BLUE BIRD

R11TA

Starter Cable May Contact Power Steering Hose

RECALL

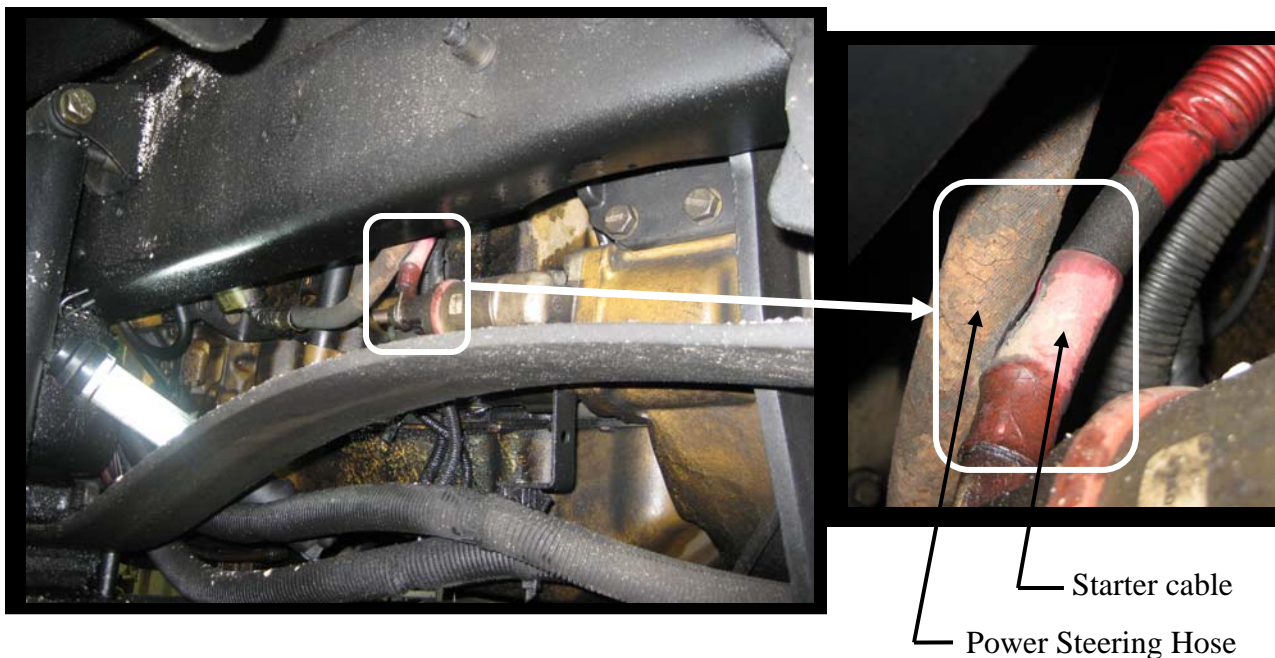
1. Park the bus on a level surface, apply parking brake, and remove ignition key and chock wheels.
2. Disconnect Batteries: Note when disconnecting the batteries, remove the Negative cable first.
3. On lower left side (driver's) of engine; inspect the positive starter cable and power steering hose for possible contact as shown below.

Inspect for proper clearance between the starter cable and the power steering hose. If insufficient clearance is found, install a clamp to prevent further contact. Any damaged power steering hoses or starter cables must be replaced.

Install dual swivel saddle mount and cable ties.

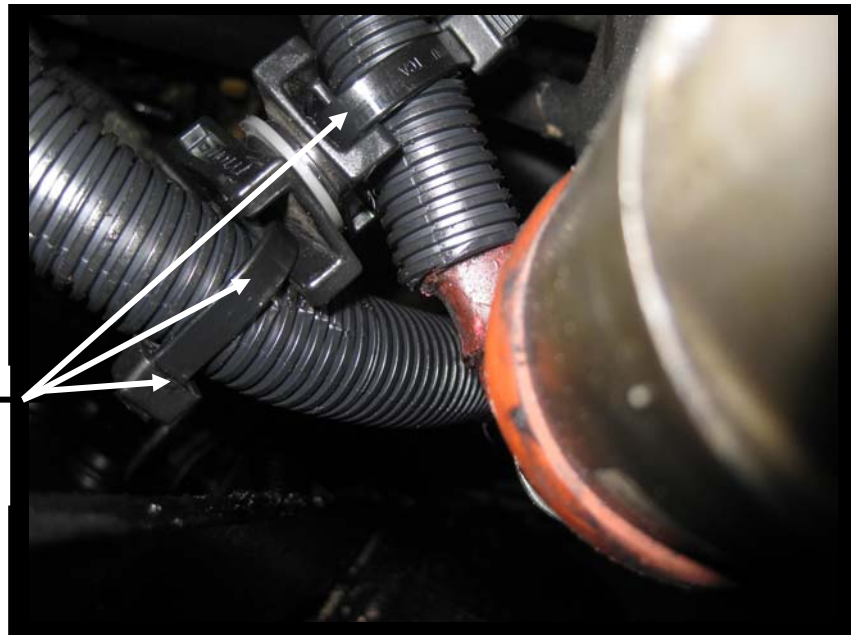
- 4. If the starter cable has contacted the power steering hose, separate and inspect both for any possible damage. If either has been damaged, contact Blue Bird Recall Administrator for a replacement.
- 5. If there is no contact and a minimum of one (1) inch clearance between the starter cable and power steering hose, no further action is required.
- 6. If there less than one (1) inch clearance, install a dual swivel saddle mount and two cables ties between the power steering hose and starter cable and secure with two cable ties.
